**REQUEST FOR INFORMATION      DATE: July 11, 2016      NO.: RFI-196**

Project Name: 15051-Webster University Interdisciplinary Science Building      Project No.: 15051

Subject: Power and Data Clarifications

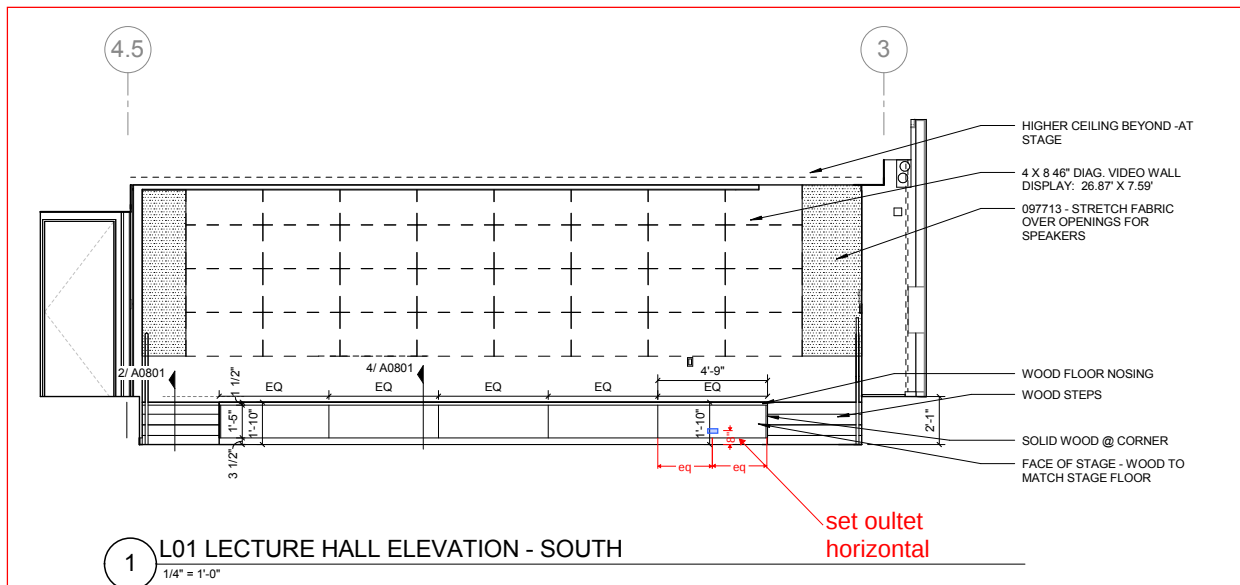
1. We need dimensions to locate the two floor boxes on the stage.
2. We need to confirm that the (2) receptacles shown on circuit 22 along column line 4.5 are to be recess mounted in the gyp board around the columns, referencing detail 11 on sheet A0810.

3. We need to confirm that the receptacle shown on circuit 22 in the front of the stage is mounted to the face of the stage. If so, is it surface mounted or recessed in the wood paneling, referencing detail 4 on sheet A0801.

4. Are the weatherproof receptacle and intercom stations shown outside of the southwest exit door to be surface mounted or recessed into the fiber cement panel, referencing wall detail WA-L2 on sheet A0400?

1. Stage outlets locations are provided with RFI 162 response
2. Yes - outlets to be recess mounted - see page 3 for detail and relocation of north outlet to other side of column cover - confirm that this can fit. Note no fireproofing on these columns.
3. Outlet to be flush with face of wood paneling - set into concrete wall as required. Locate per below drawing.
4. Intent is to recess into fiber cement panel assembly. Detail will be provided with ASI.

**T0101.B**

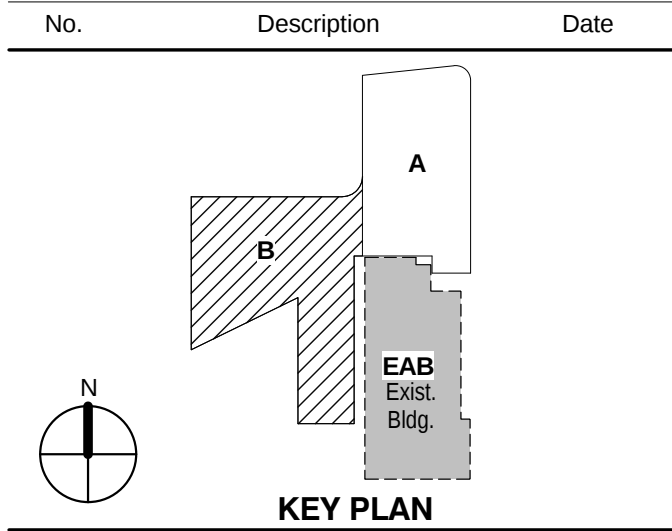
5. Drawing T0101.B, keyed note 23, indicates rough-in for multiple video monitors mounted on the back wall of the stage, but there is no power shown on sheet E0101.B for them. Is there power required to be run to the monitors?

6. Drawing T0101.B, keyed note 23, indicates rough-in for a subwoofer under the stage. How does it mount under the stage?

Item #5 - Power will be required. We are awaiting the final AV design package from Webster University's AV consultant. Final monitor rough-in requirements will be included in an upcoming drawing revision.

Item #6 - We are awaiting the final AV design package from Webster University's AV consultant. Final subwoofer rough-in requirements will be included in an upcoming drawing revision.
